**MADERA UNIFIED  
SCHOOL DISTRICT**  
1902 Howard Road  
Madera CA 93637  
(559) 675-4500  
(559) 675-1186 Fax  
[www.madera.k12.ca.us](http://www.madera.k12.ca.us)

Addendum No. 1-Bid Section 1-5  
Asphalt Resurface & Repairs at Various School Sites  
BID No. 033116

This Addendum is attached to and made a part of the above entitled specifications for Madera Unified School District for BID No. 033116 with a due date of May 5, 2016

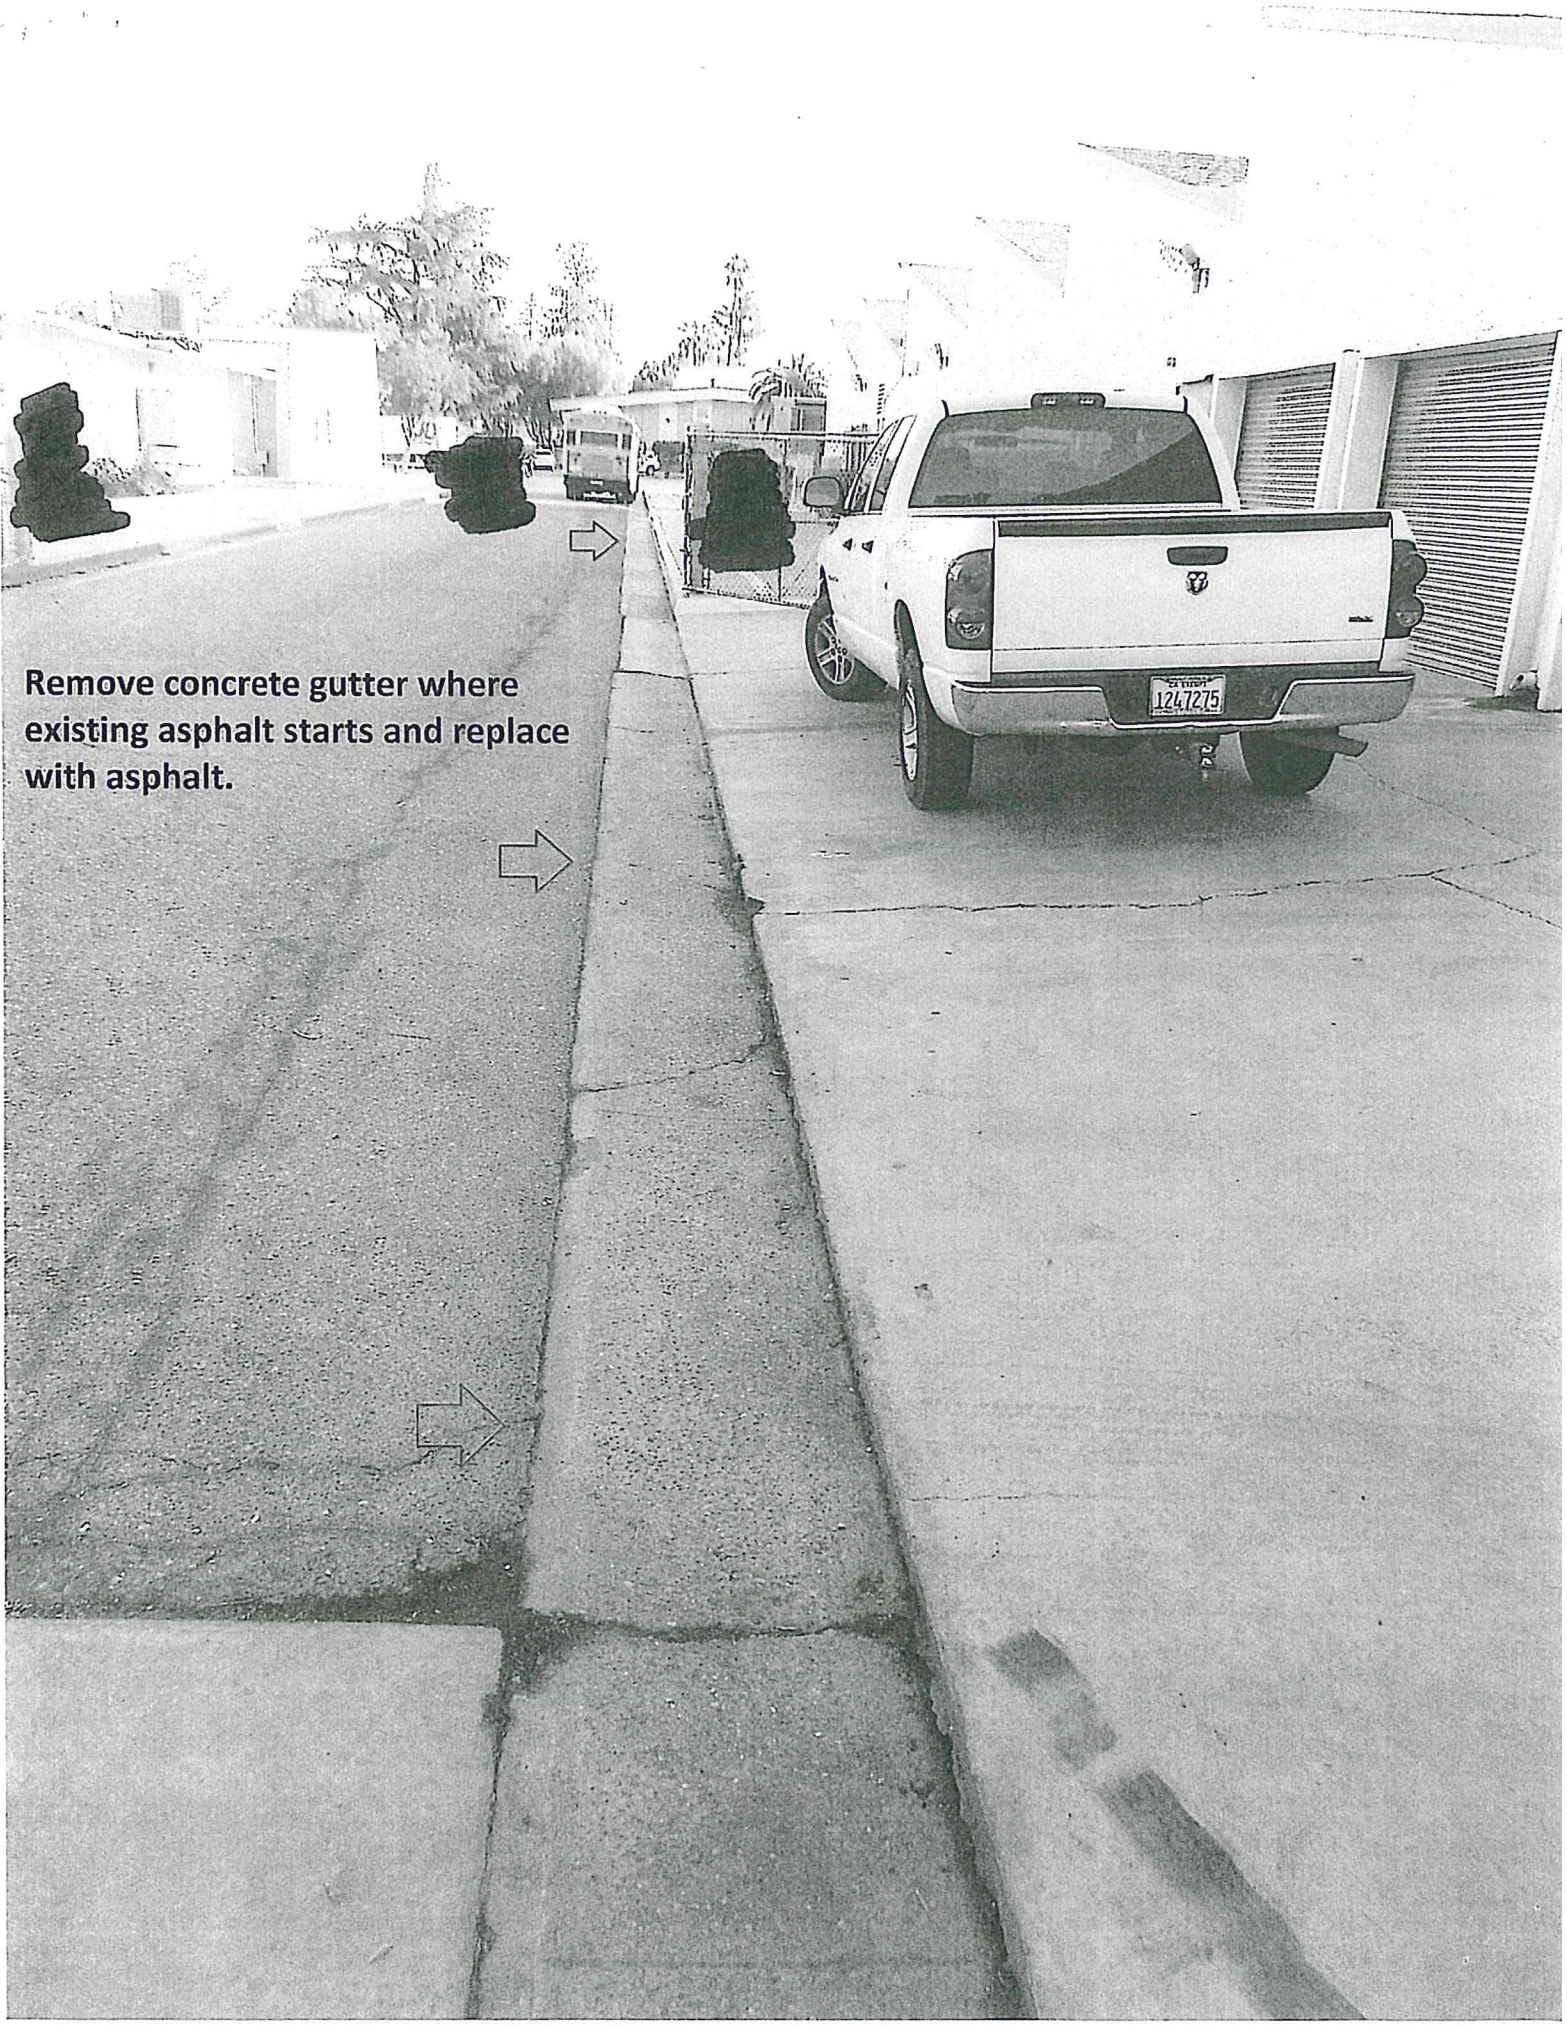
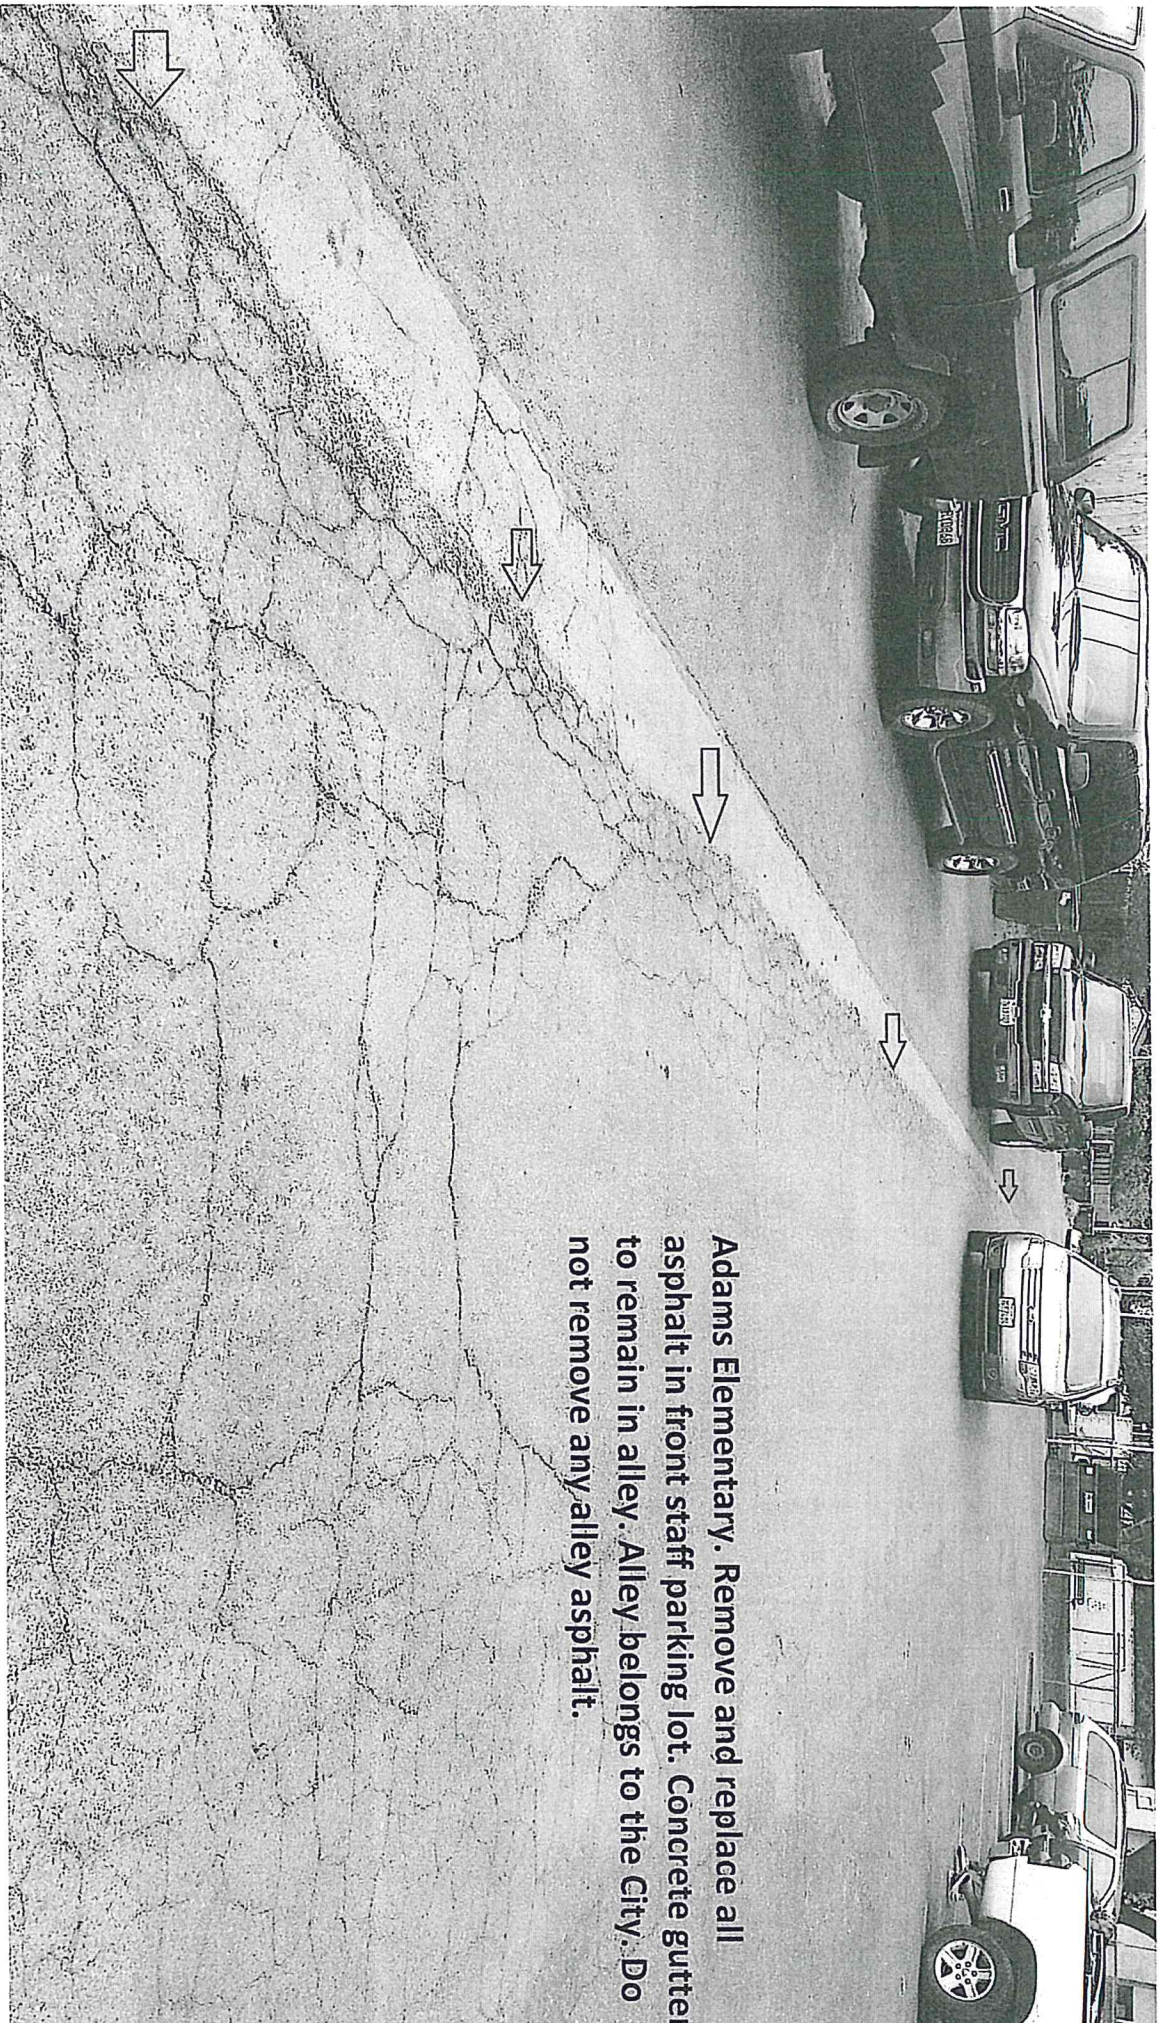
Madera High School. Remove concrete trench and replace with asphalt. Concrete drain/gutter to remain.

**Remove concrete gutter where  
existing asphalt starts and replace  
with asphalt.**

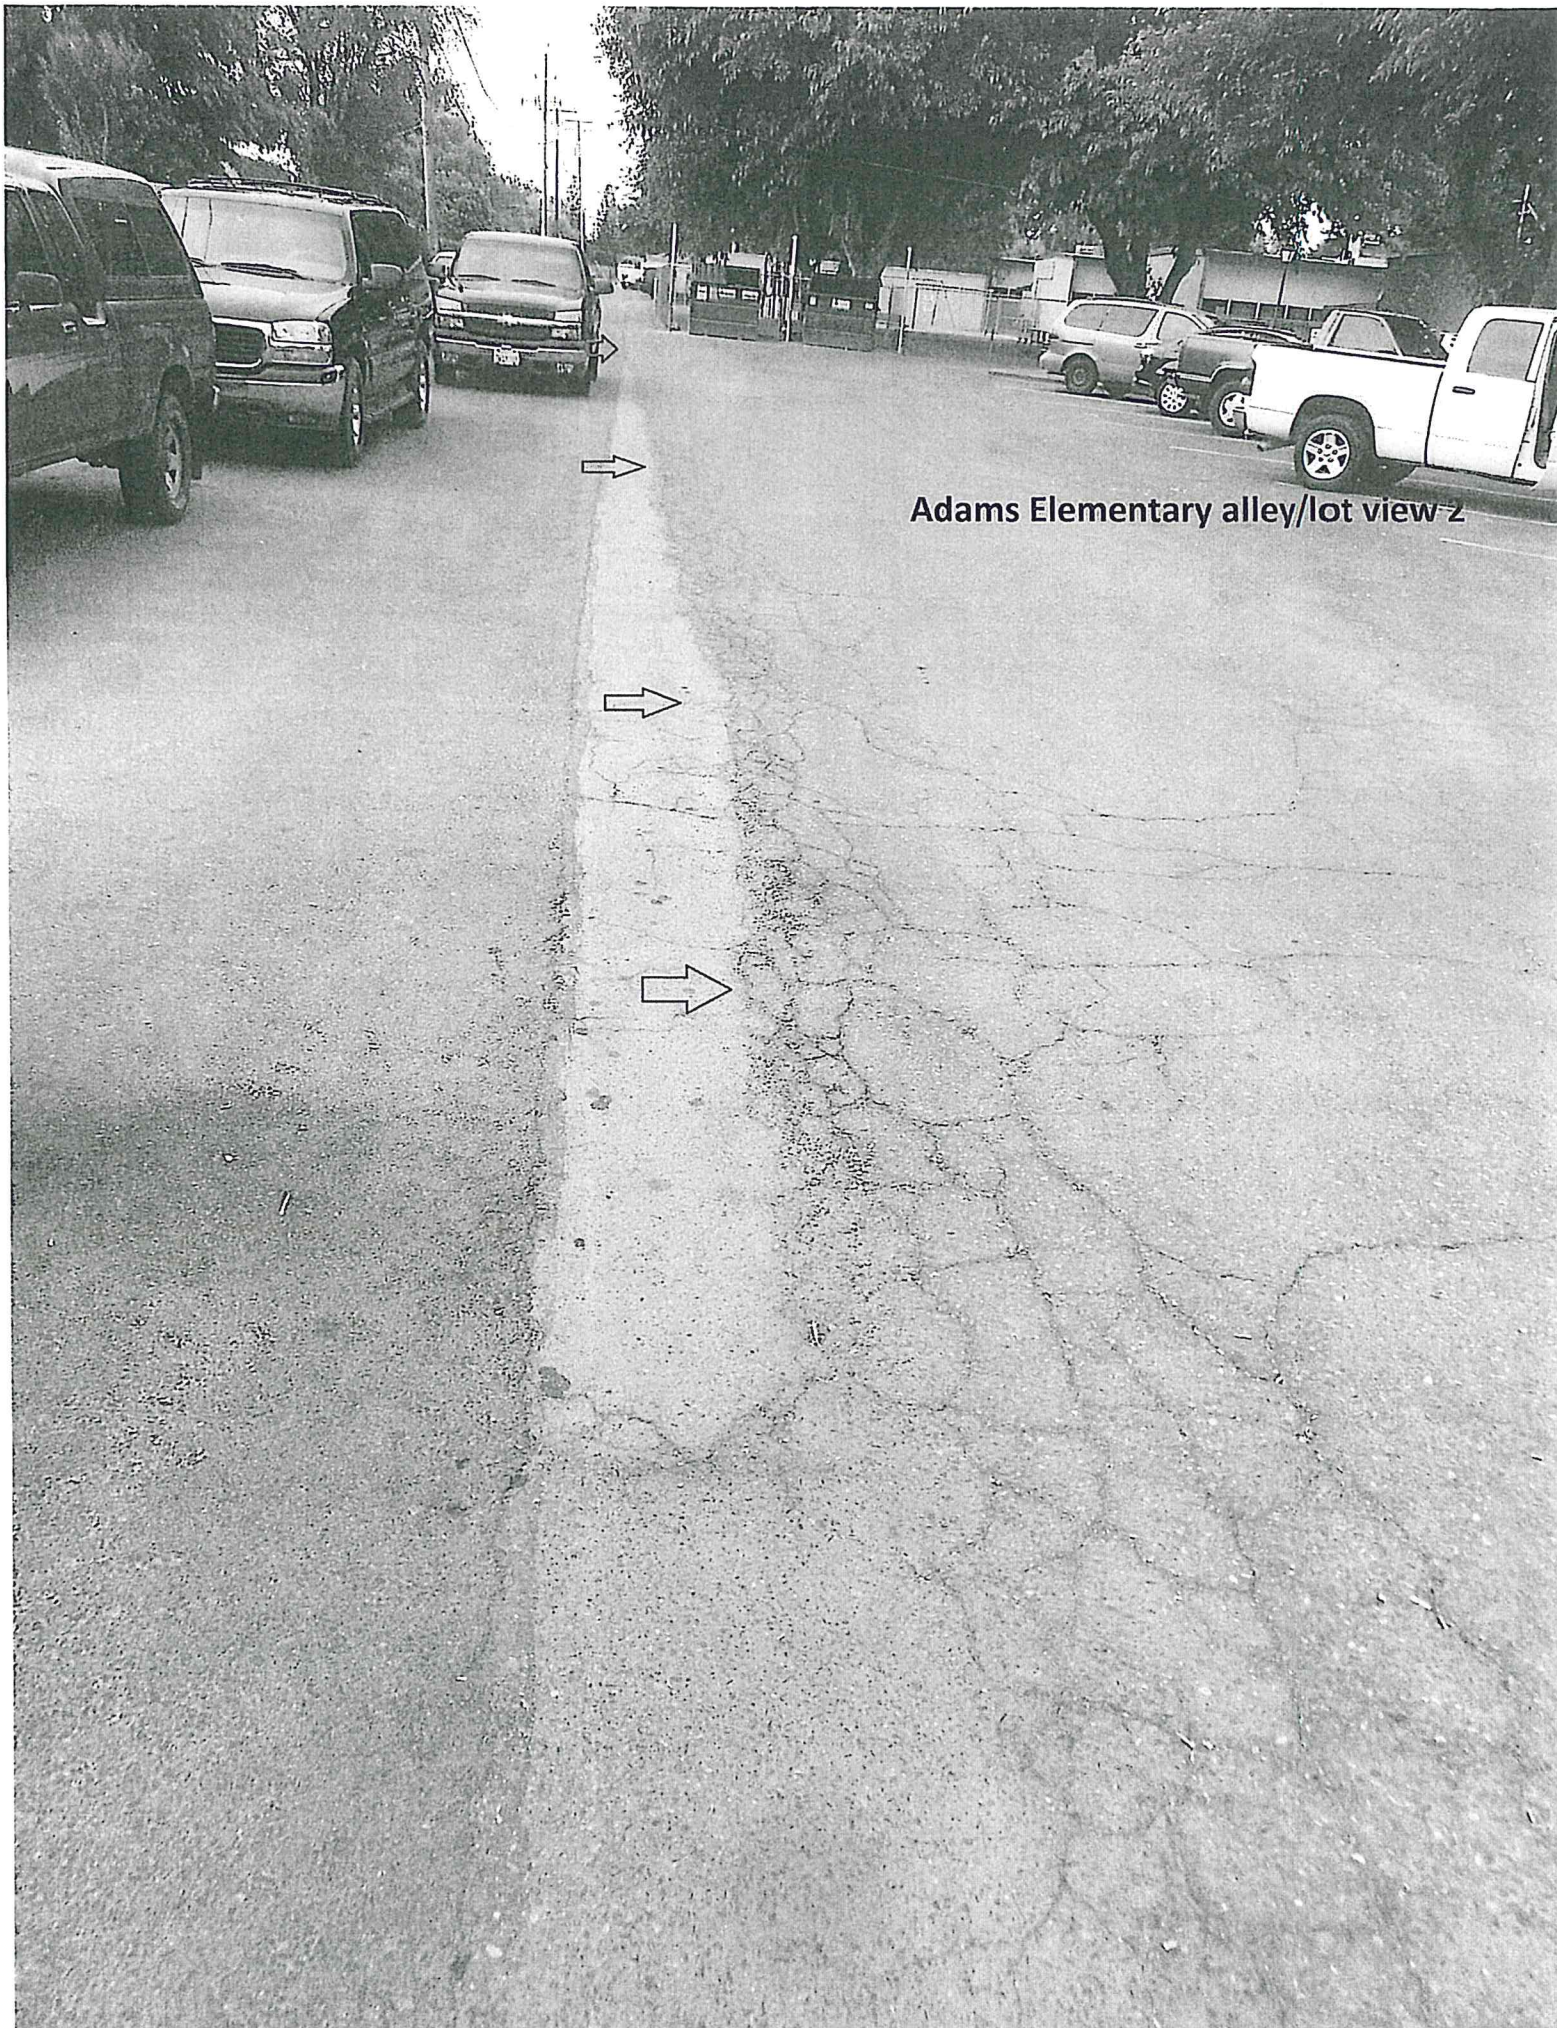
Adams Elementary. Remove and replace all asphalt in front staff parking lot. Concrete gutter to remain in alley. Alley belongs to the City. Do not remove any alley asphalt.
